DATE: September 22, 2020
TO: Blue Bird Owners
Subject: FMVSS 222 Noncompliance Seat Barrier Install Behind Driver Seat Integrated 3-Point Seatbelt

IMPORTANT SAFETY RECALL NOTICE
NHTSA Recall Number: 20V-125 School Bus

R20AM Seat Barrier Install Behind Driver Seat Integrated 3-Point Seatbelt

Photo 1

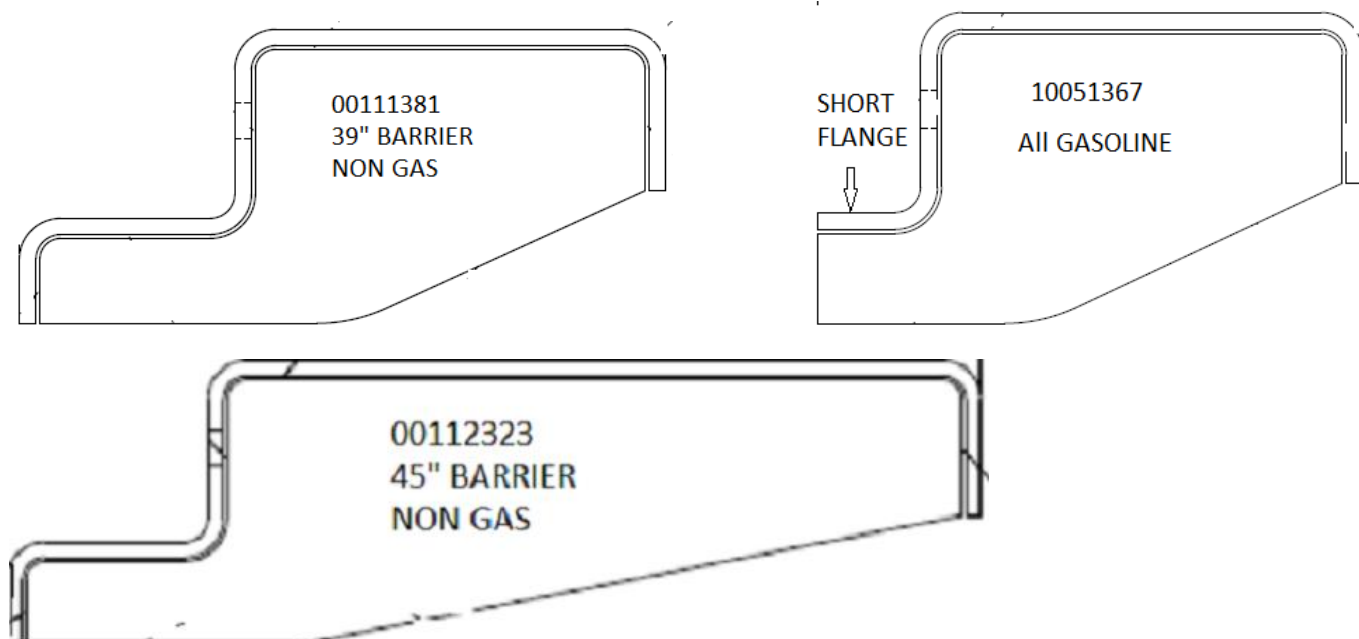
Ensure the correct barrier is installed. Do this by visually inspecting the underside of the barrier frame at the wall bracket. If the inside frame tubing is hollow it is the incorrect barrier and will need to be changed. If the inside barrier tubing is solid the barrier is correct as the reinforcement has been welded into place. **See Photo (1)**

Photo 6

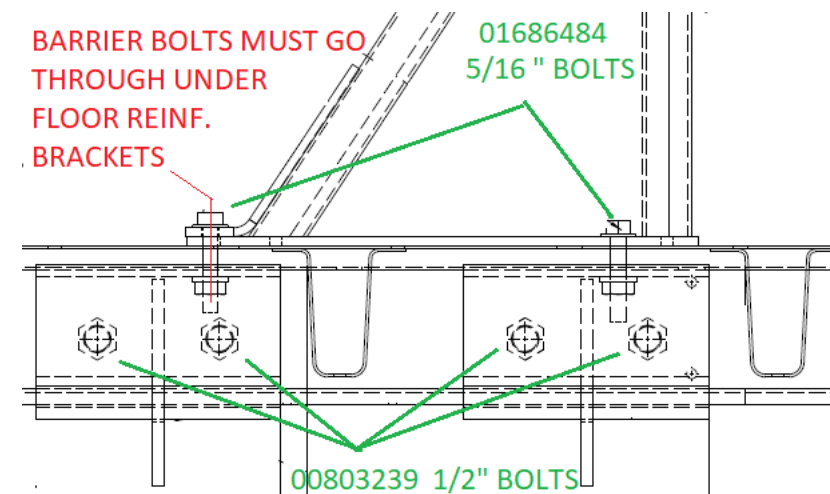
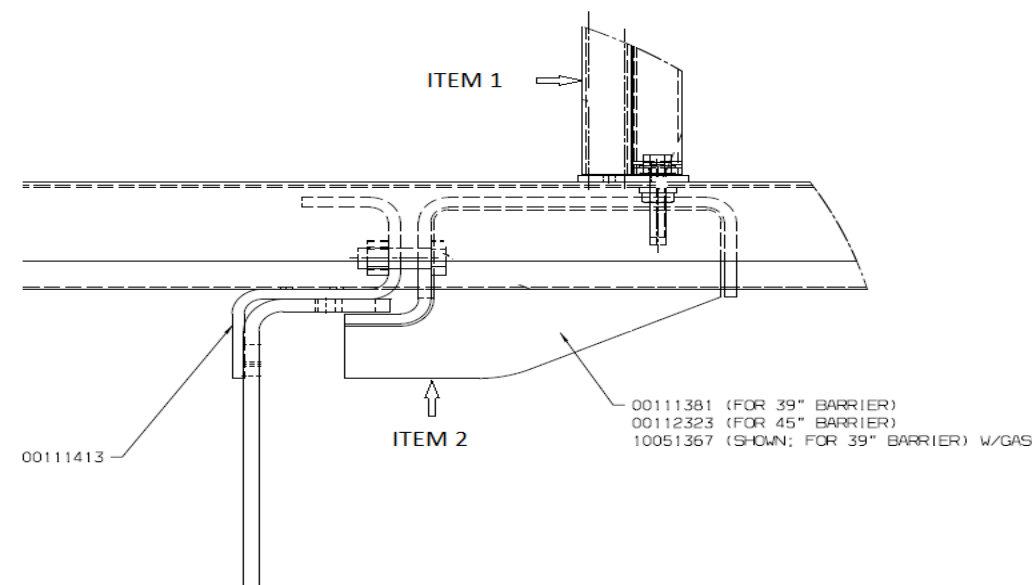
1. Remove the two bolts that secure the barrier leg to the floor. See Photo (2)
2. Place the inside and outside reinforcement brackets into the proper location using the existing holes for the barrier leg, as referenced.
3. Secure the inside and outside reinforcement brackets into place using the 1/2-13 X 1 1/2, GR8, bolts included in the kit, (Torque to 70 ft/lbs.) See Photo (6) OR (7) DEPENDING ON YOUR VEHICLE
4. Once both reinforcement brackets are in place back drill the barrier leg holes using a 11/32" drill bit. (Under floor brackets must be located correctly, when back drilled for barrier bolts to go into them).
5. Install the barrier leg 5/16 bolts and nuts included in the kit and torque to 12-15 ft./lbs.
